**RE: Harbor Grove Preliminary Plat Application  
9110 53<sup>rd</sup> Ave W**

This letter provides additional details in support of issues raised in my previous comment letter dated November 30, 2021 on the proposed subdivision.

*Figure 1 – Detention Vault “Bypass Basin” Area (highlighted in yellow)*

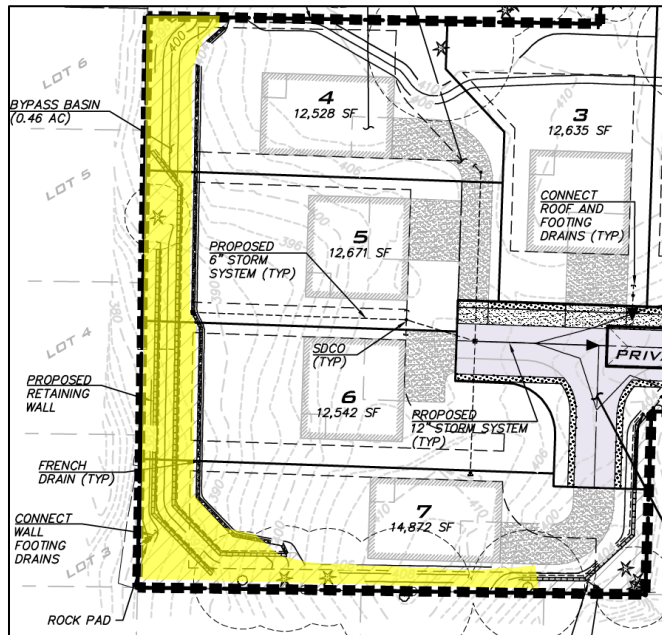
- C. Bypass Basin. The drainage study identifies a "bypass basin" consisting of 0.46 acres of land that will not drain to the detention vault (see pages 4.3, 4.4 and Developed Conditions Exhibit and Figure 1 below). This area is located along the west and south property lines of the project site and directly abuts several properties in Rugosa Ridge. The drainage study contains no analysis of potential impacts on adjacent properties and must be amended to address this issue since nearly 20% of the developed project site will bypass the storm system and flow to adjacent properties. The amount of runoff generated post-development from the bypass basin would exceed runoff from existing

conditions as a result of removal of all existing vegetation. This information also supports a requirement for a groundwater study.

**Figure 2 – Areas of 35-40% slopes**

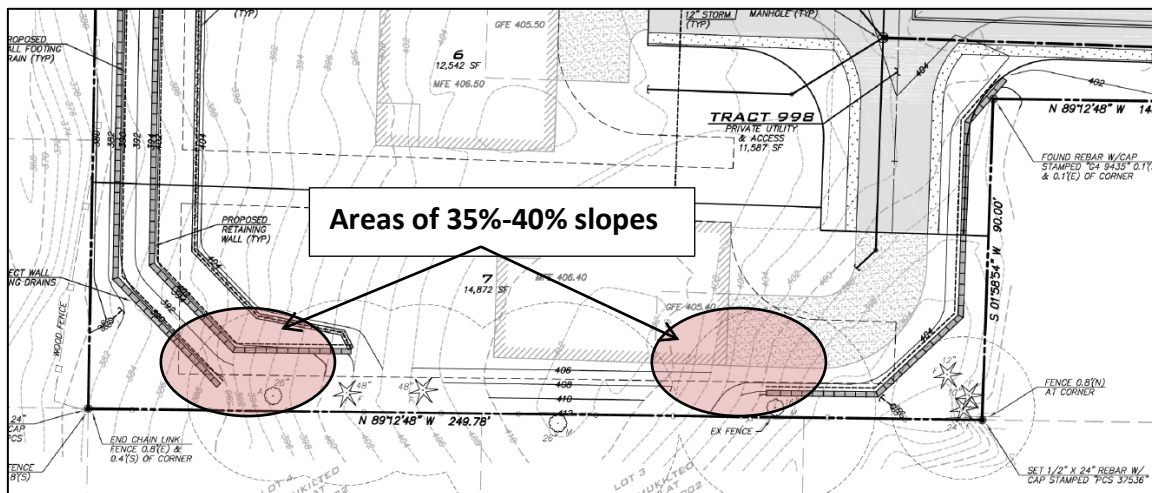
2. Groundwater/Hydrology Study. The need for a groundwater/hydrology study is further supported by the following:
  - A. 15.16.050.C.2.b.i.(b), which requires a slope and hydrology report when clearing/grading on slopes greater than 35%. The south and southwest portions of the site contain slopes greater than 35% (see Figure 2 below from Grading Plan, Sheet 5). I calculated slopes up to 40%.
